Red Line Revision No. 1
Dated 05-19-05

Revision "G"

MARYLAND DOT - STATE HIGHWAY ADMINISTRATION
Office of Traffic & Safety
TRAFFIC ENGINEERING DESIGN DIVISION
(Traffic Signal Plan)

MD 177 at MD 607/Magothy Bridge Road

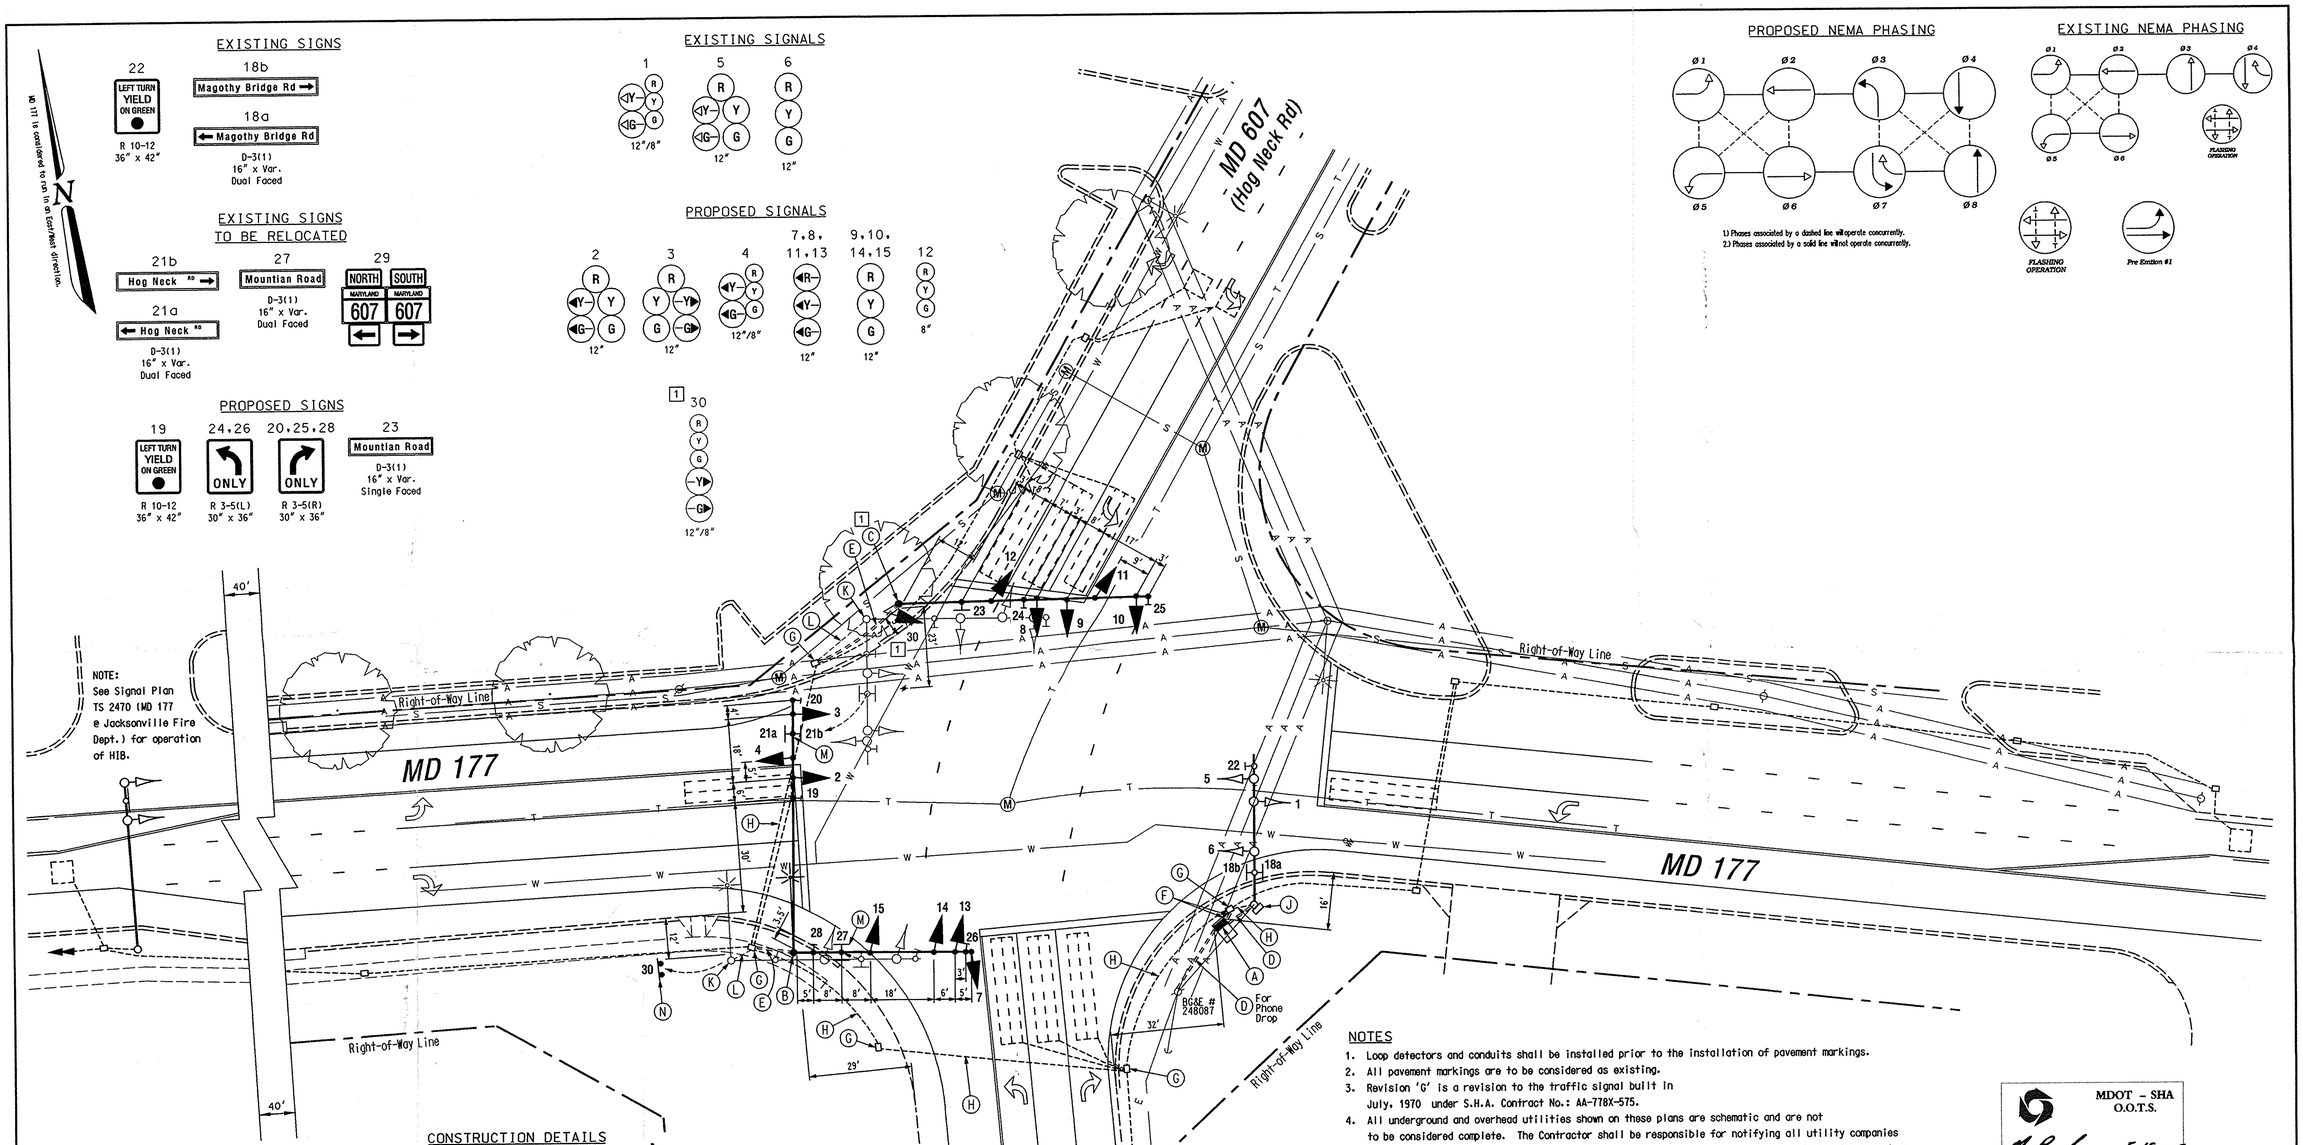
REVISIONS	
©	June 23, 2003
	Replace N/S Split Phase w/ Exclusive Lt's.
S.H.A. No.:	BW996M82
JJD
